SUBJECT: Addendum No. 1 (revision 1)  
IFB No. 26M-0201 Maluhia Cooling Tower Replacement

## ADDENDUM NO.1

### **MALUHIA HOSPITAL COOLING TOWER REPLACEMENT**

**CWP-1:**

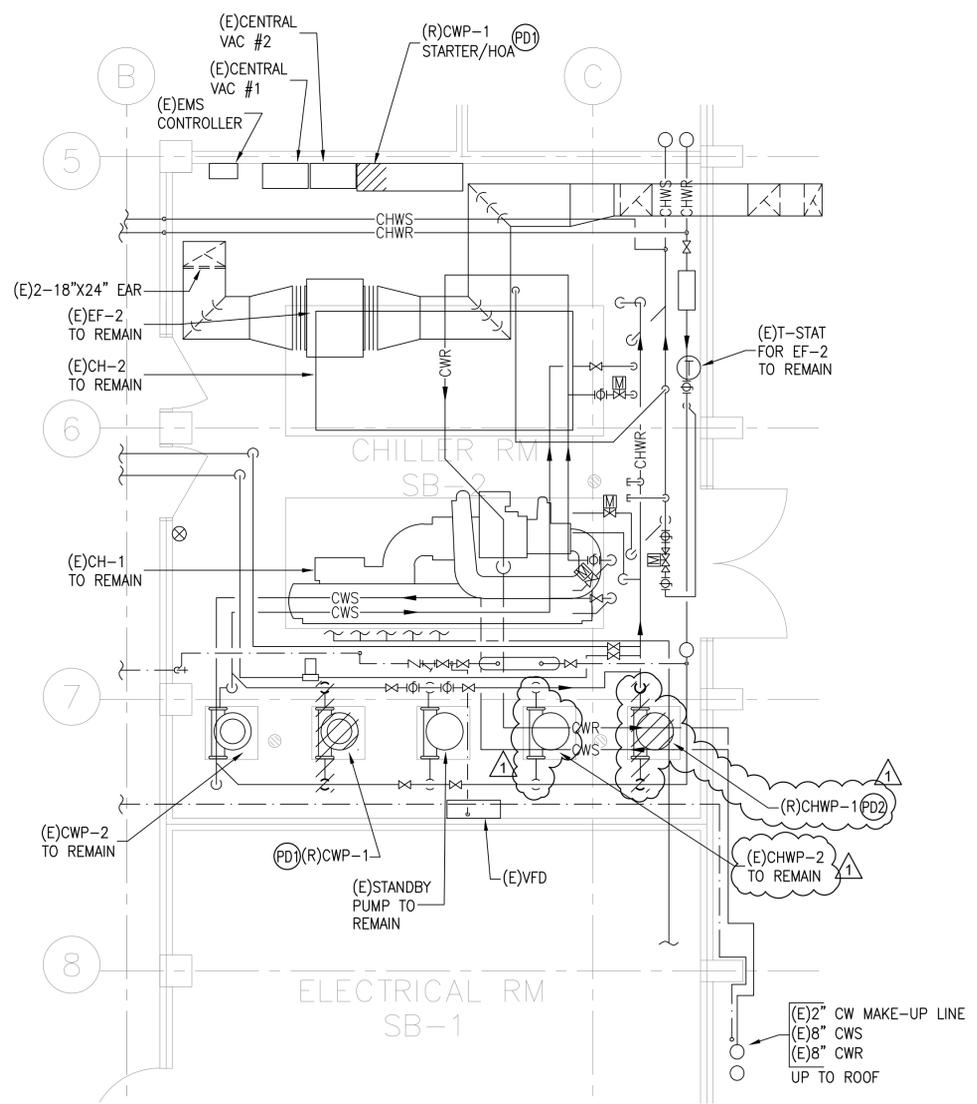
Plad Vis model VIS 4X4X13A 1CBF1 – Note Marking on Submittal. Ensure that the manufacturer pump shaft is constructed of stainless steel. Contractor shall make necessary adjustments to accommodate manufacturer suction diffuser and triple duty valve. No Exception Taken.

Drawing Number  
**M101**

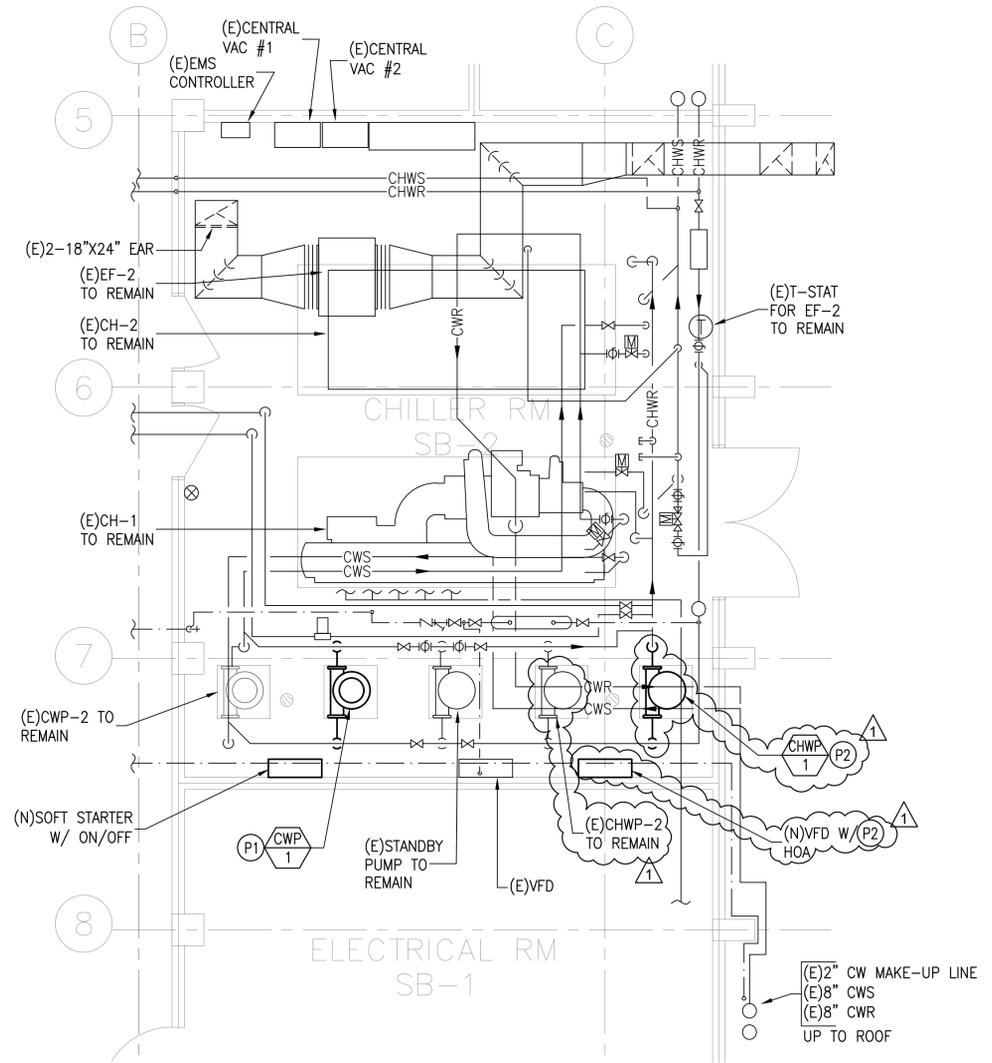
Correct Chilled Water Pump (CHWP)-2 to remain as existing, and revise CHWP-1 to be removed completely per revised demolition notes. Revised new floor plan to indicate CHWP-2 to remain as existing, and CHWP-1 to be a new pump with Variable Frequency Drive (VFD).

Drawing Number  
**M201**  
 Sheet No. 7 of 14

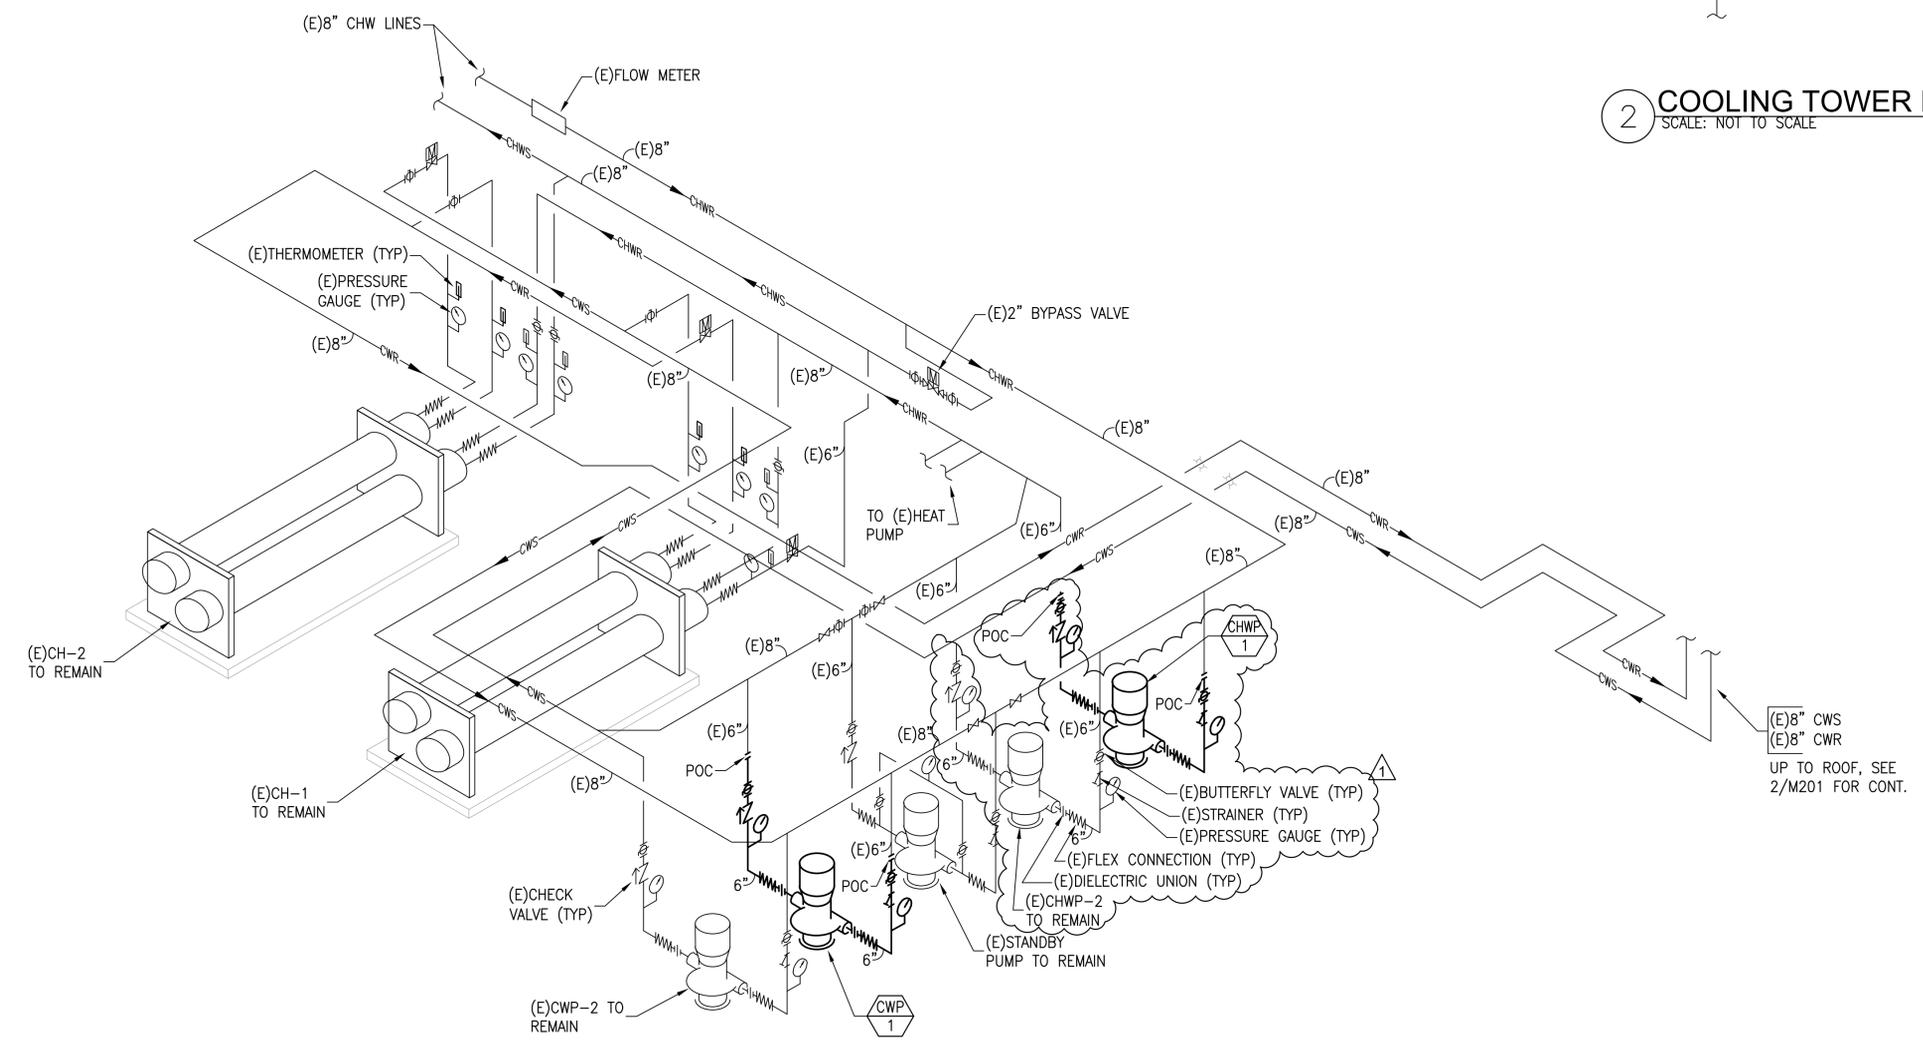
Correct Chiller Plant Diagram to match with floor plan.

M301

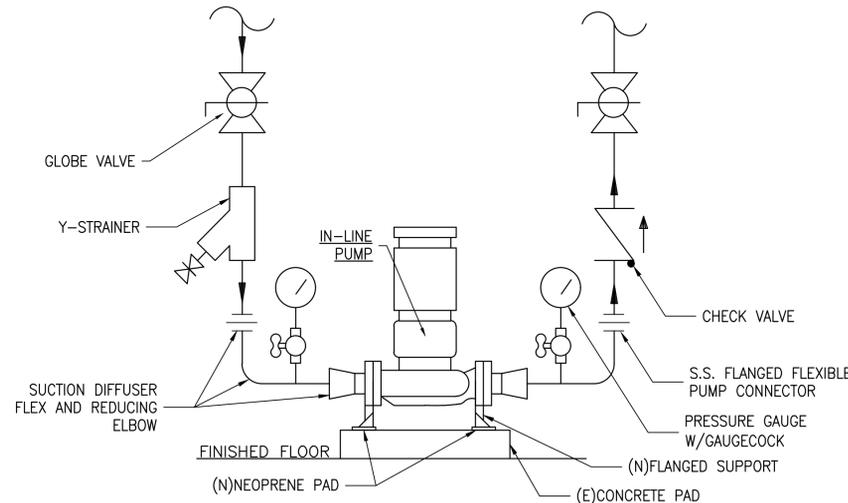
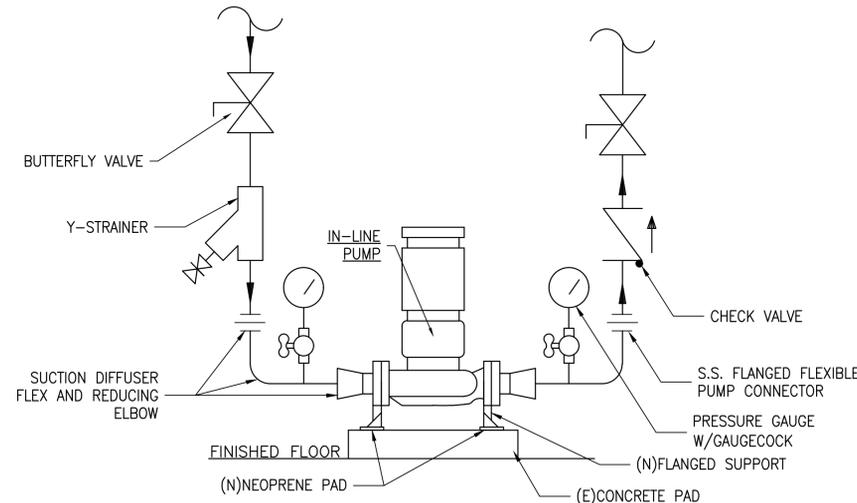
Revised Chilled Water Pump Schedule to show correct pump callout.

PARTIAL SUB-BASEMENT ELECTRICAL PLANS - DEMOLITION AND NEW WORK

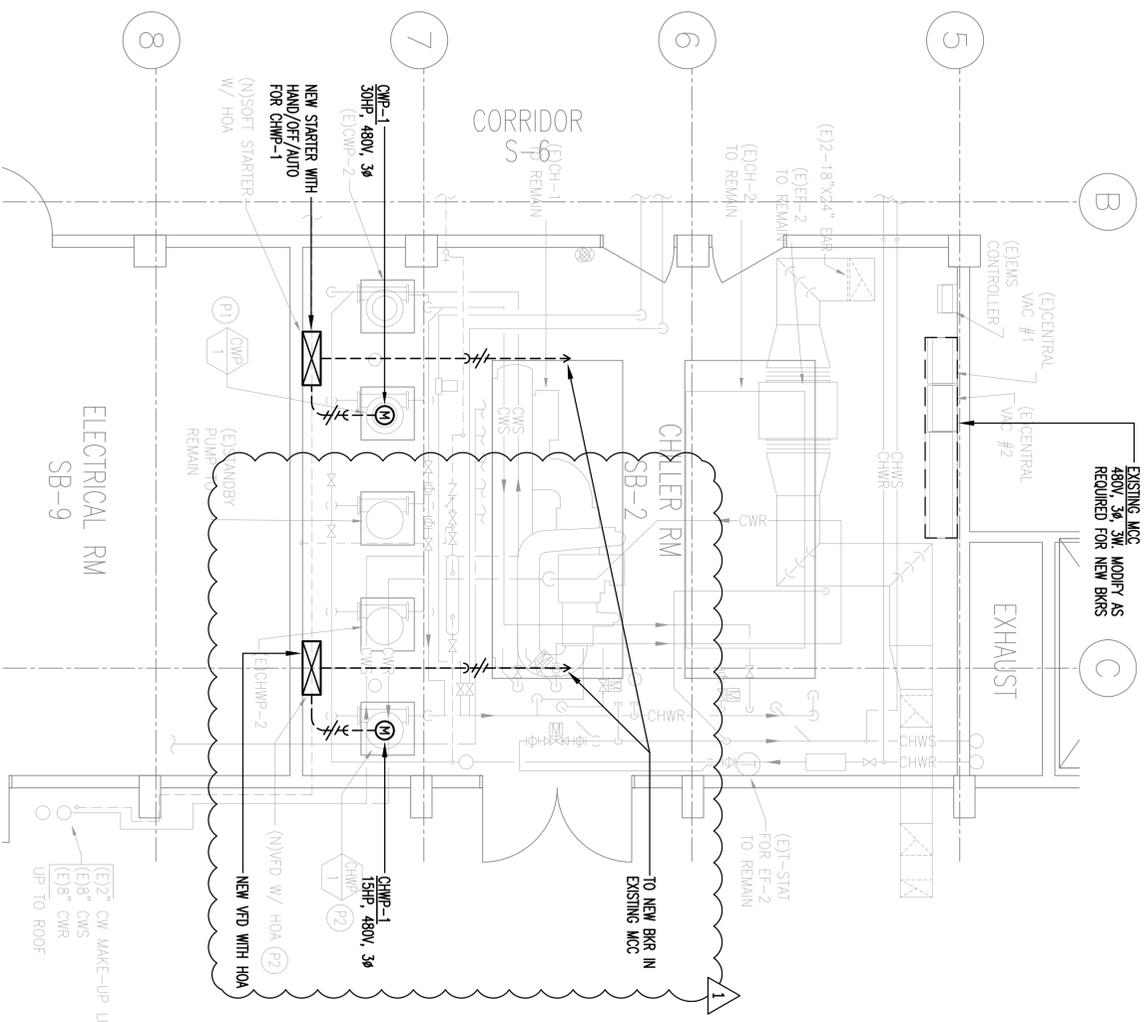
Revise demolition and new plan to match with mechanical changes.

SINGLE LINE DIAGRAMS - DEMOLITION AND NEW WORK

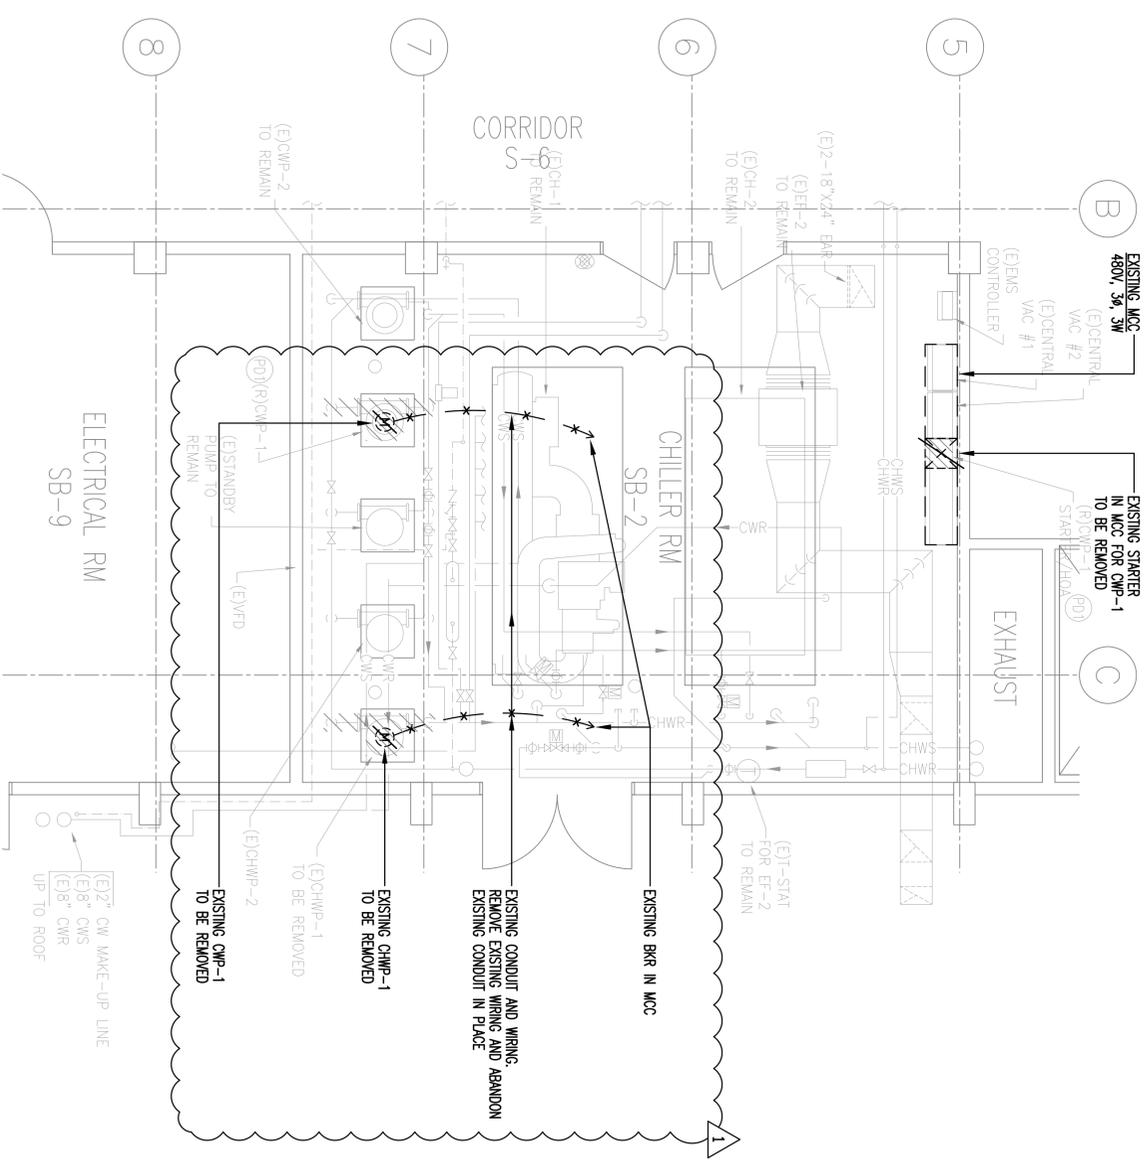
Revised single line diagram to reference correct pump per mechanical changes.
